From: Hamak Kevin [mailto:HAMAK@johnrmcadams.com]
Sent: Thursday, November 08, 2007 2:42 PM
To: Keith Megginson; jason.sullivan@ncmail.net
Cc: Finch, Jeremy; Ihnatolya, Beth
Subject: Briar Chapel Perimeter Buffer

BRIAR CHAPEL
PHASE 5 NORTH - SECTION 2
CHATHAM COUNTY, NORTH CAROLINA

GRADING, DRAINAGE &
STAGE 2 EROSION CONTROL PLAN

Re: Phase 5 North Final Subdivision Plat

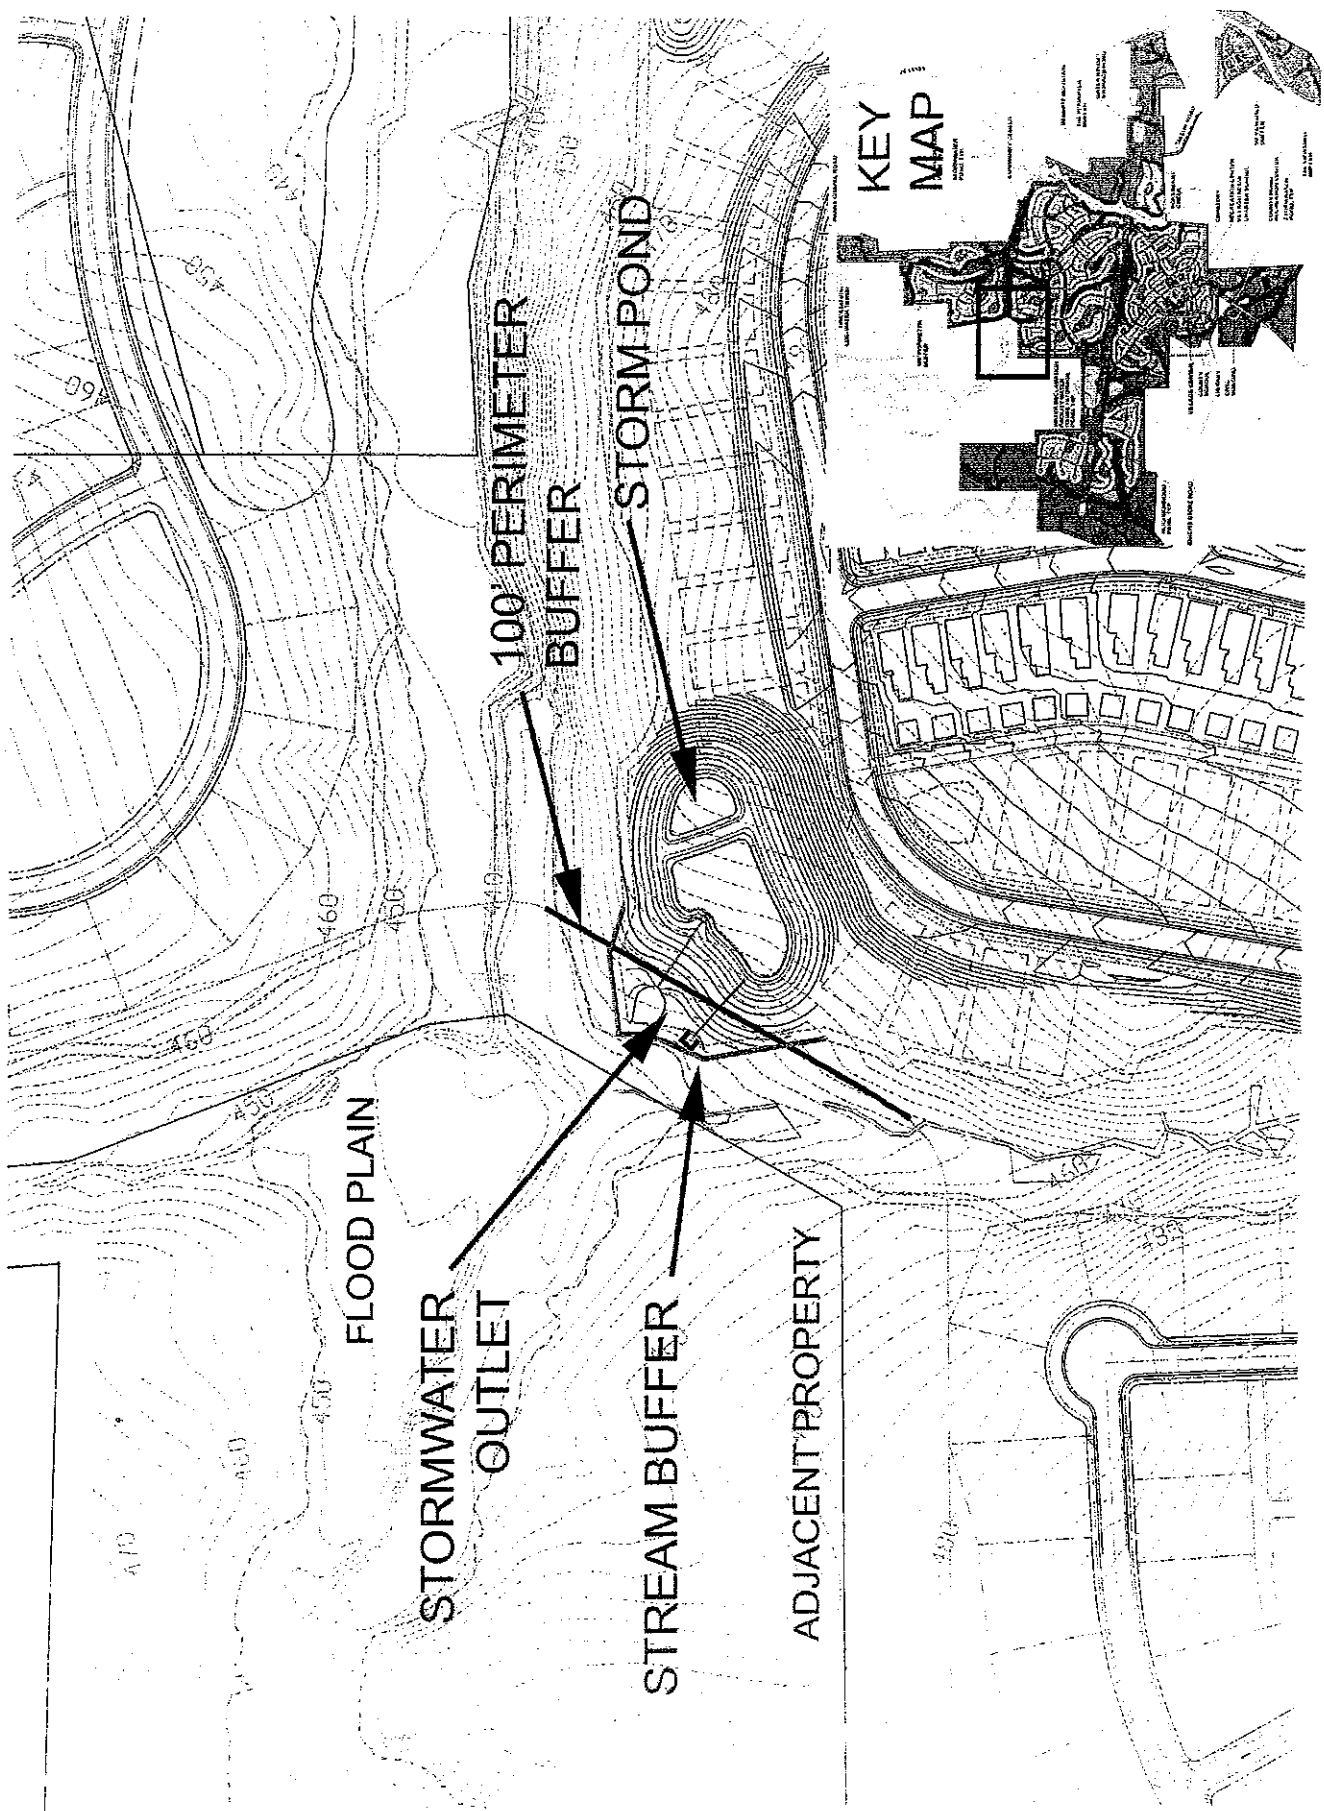
We have encountered our first situation where we have a storm water pond adjacent to a perimeter buffer. What are the restrictions as far stormwater devices in the perimeter buffer. The attached exhibit shows the level spreader and riprap in the 100' perimeter buffer. We are staying out of the stream buffer which is inside the perimeter buffer and the adjacent land is a floodplain and vacant property.

Are we allowed to have these stormwater devices in the perimeter buffer? The CCO does not specify that I could find.

Kevin,
Keith and I talked about this issue and have determined that the perimeter buffers are to remain undisturbed. All of the grading and components associated with the stormwater devices should be located outside of the perimeter buffer. Section 9.2 of the Compact Communities Ordinance covers perimeter buffers and the last part of this section titled Perimeter Buffer Vegetation and Land Uses indicates that these areas should remain in their natural state or be improved with plantings. Let Keith or me know if you have any further questions.
